SURFACE TRANSPORTATION BOARD

Office of Environmental Analysis

Re: Docket No. FD 35852, Canaveral Port Authority— Construction and Operation Exemption — Rail Line Extension to Port Canaveral, Fla; Information Request #4

Port Canaveral Rail Extension: CPA-Proposed Options and USAF Avoidance Areas

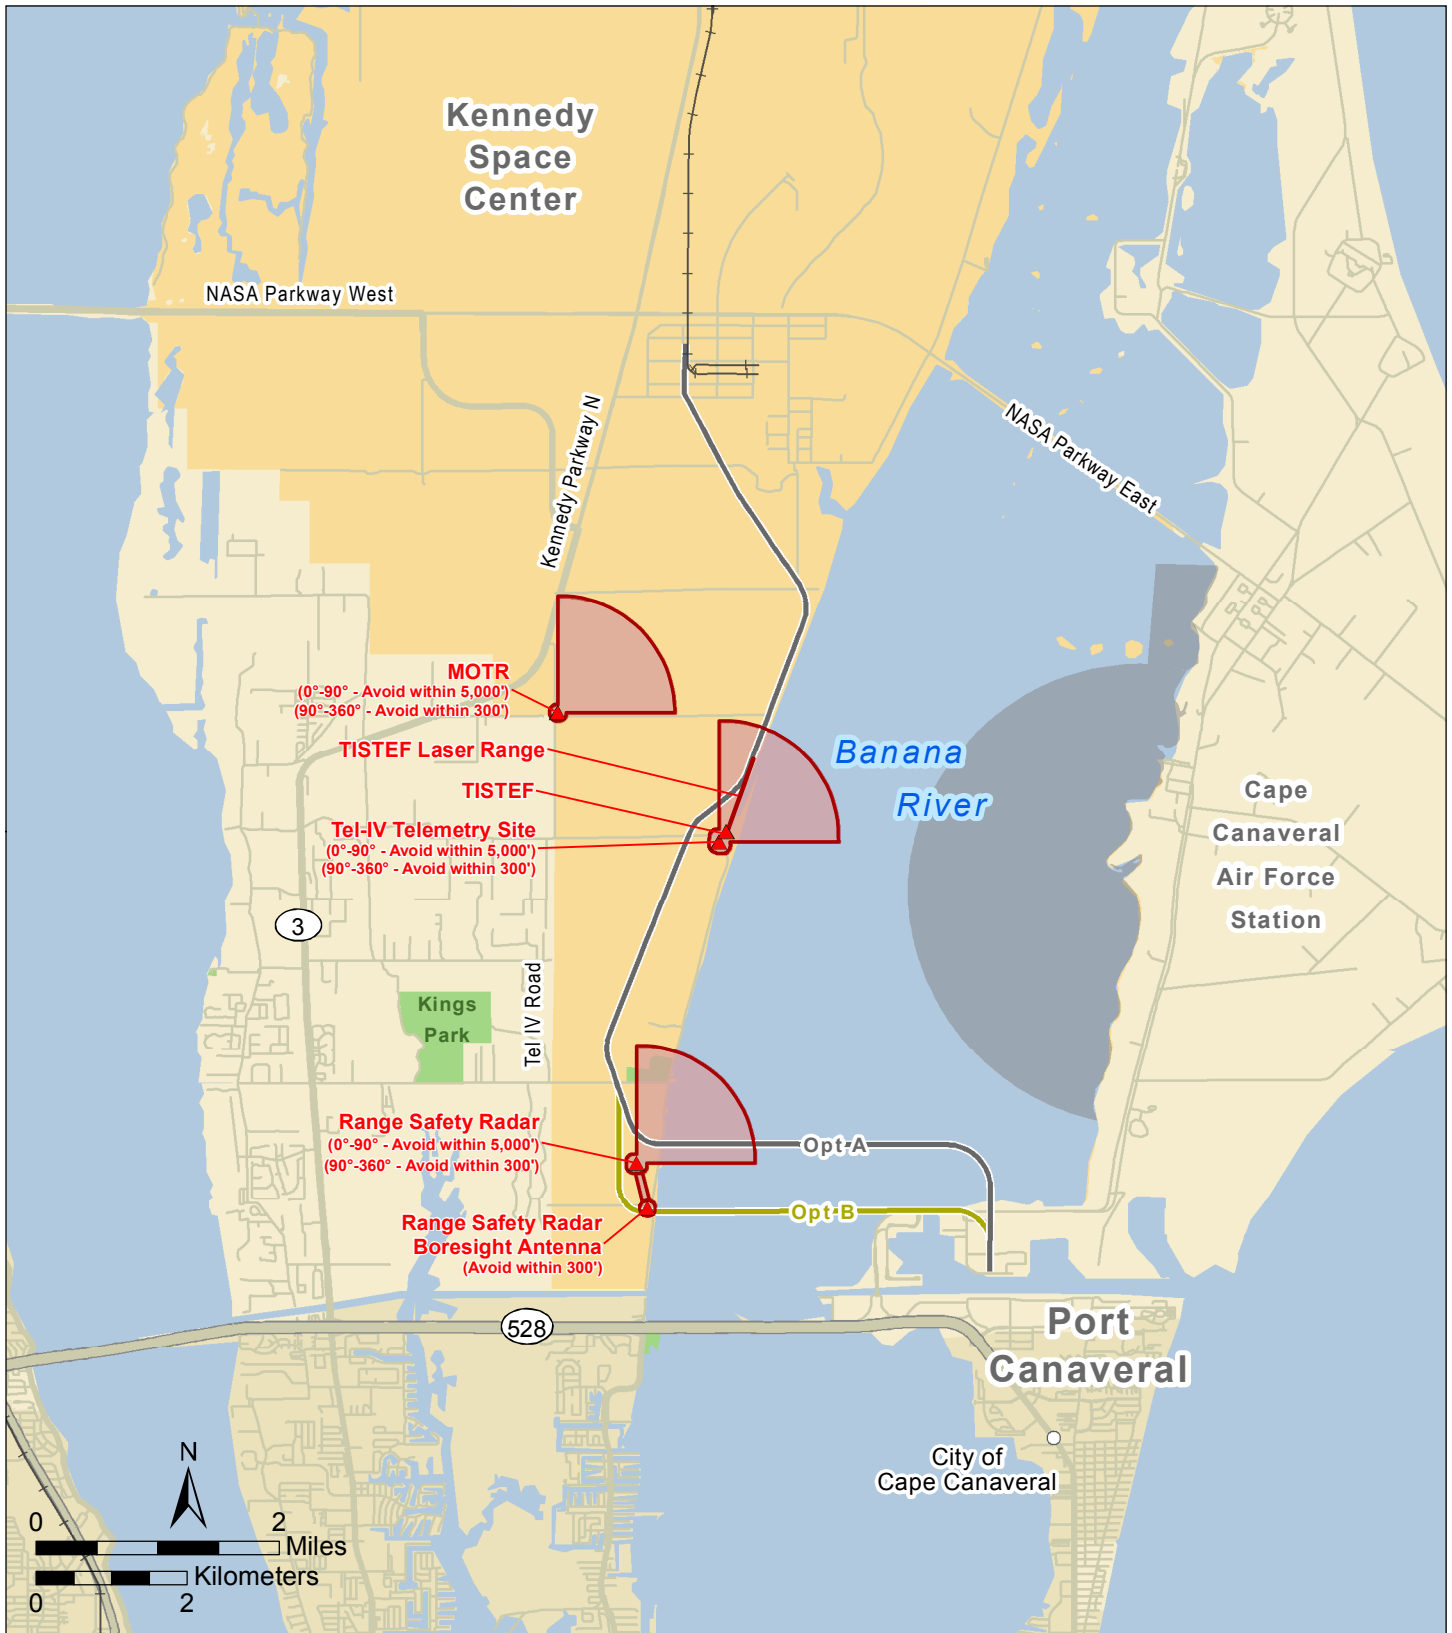
1. The enclosed map depicts CPA's proposed rail alignment through Merritt Island (including Options A and B for a potential Banana River crossing) and avoidance zones associated with the Range Safety Radar, Range Safety Radar Boresight Antenna, Tel-IV Telemetry Site, and Multiple Object Tracking Radar (MOTR). As depicted on the map, the CPA-proposed rail alignment encroaches on the larger avoidance zone for the Tel-IV Telemetry Site (i.e., a zone defined by a 5,000-foot radius of the telemetry site from 0 degrees north to 90 degrees east). Please identify an adjustment to CPA's proposed rail alignment that would avoid the Tel-IV Telemetry Site's avoidance zone. Any adjustment should be designed to a level equivalent to approximately 15 percent engineering design. Please provide OEA with shape files or files in a KMZ format and design drawings and diagrams that include the items listed below, as applicable:
